UNITED STATES PATENT AND TRADEMARK OFFICE

APPLICATION NO.	FILING DATE	FIRST NAMED INVENTOR	ATTORNEY DOCKET NO.	CONFIRMATION NO.
09/588,478	06/07/2000	Yasuhiro Morii	50073-030	8907

Office Action Summary

DETAILED ACTION

Fig. 5a

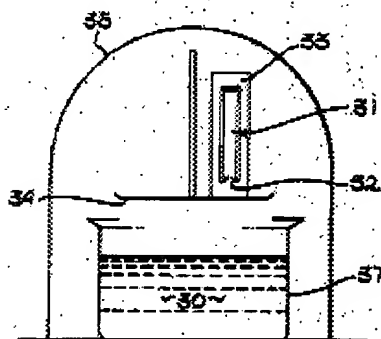
Yih teaches in Figures 1-6 the steps of adhesive application, evacuation, filling, sealing, etc. (Figures 1-5b, and col. 2, line 41 through col. 4 line 52) comprising forming a sealant between the two substrates (col. 3, lines 20-35) and around the outer peripheries of the substrates in such a manner that it partly reaches the edges of the substrates to form an opening (col. 3, lines 23-28) through which liquid crystal is to be injected into the space between the sealed substrates, and a step of setting the panel in a liquid crystal-injecting unit (col. 4, lines 10-17) having therein a container filled with liquid crystal, evacuating both the liquid crystal-injecting unit and the panel, putting the opening of the panel into the liquid crystal in the container (col. 5, lines 26-31), thereafter restoring the liquid crystal-injecting unit to have an atmospheric pressure (col. 4, lines 13-19 and col. 5, line 32 through col. 6, line 5) in that condition so that the liquid crystal is injected into the panel through its opening owing to the inner pressure difference between the unit and the panel (col. 4, lines 15-17), and finally sealing the opening of the panel in such a condition that the panel receives no external pressure (col. 4, line 19) to complete LCD assembly without bubble formation.

Yih teaches forcing the liquid crystal into the LCD assembly by replacing the partial vacuum with a non-reacting gas (therefore at atmospheric pressure) (col. 6, lines 1-3). Yih teaches sealing after removal from the vacuum which would result in the panel receiving no external pressure (col. 4, lines 18 and 19), and Yih teaches sealing *after* removal of the LCD device from the liquid crystal material after filling (col. 6, lines 14-21), and that could not be accomplished without introducing a bubble (avoided by the process of Yih) if the inner pressure were any lower than atmospheric pressure, especially by as much as 0.3 kgf/cm^2 .

FIG. 2B

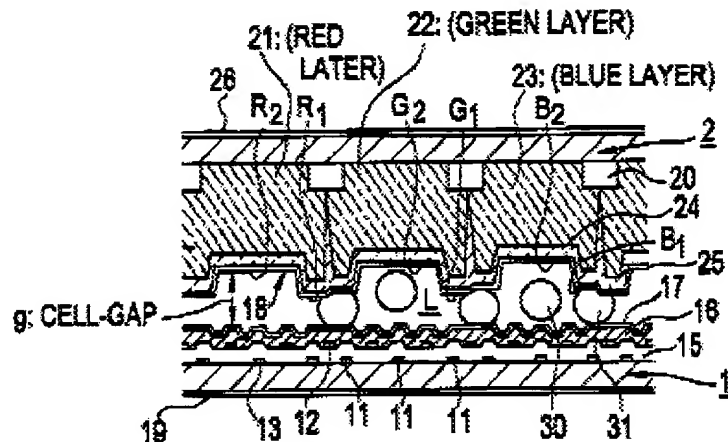
Suzuki teaches in Figures 2A and 2B defining a gap between the first and second substrate by disposing a spacer, 31, which is smaller than said gap, on a projecting pattern where spacers, 30, remain uncompressed so the liquid crystal molecules will not be subject to anomalous orientation and light leakage will be avoided (Abstract).

Suzuki is evidence that ordinary workers in the art of liquid crystals would find the reason, suggestion, or motivation to define a gap between the first and second substrate by disposing a spacer which is smaller than said gap, on a projecting pattern where spacers in the pixel regions remain uncompressed so the liquid crystal molecules will not be subject to anomalous orientation and light leakage will be avoided.

FIG.2

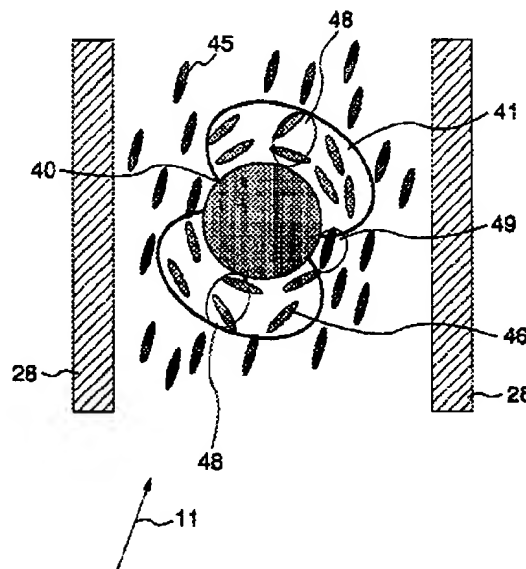
Utsumi teaches in Figures 1, 2, and 9, the use of long-chain alkyl group coated spacers (col. 10, lines 8-11) to improve contrast and viewing angle (col. 5, lines 36-40, col. 9 and Abstract).

Utsumi is evidence that ordinary workers in the art of liquid crystals would find the reason, suggestion, or motivation to add the use of long-chain alkyl group coated spacers to improve contrast and viewing angle.
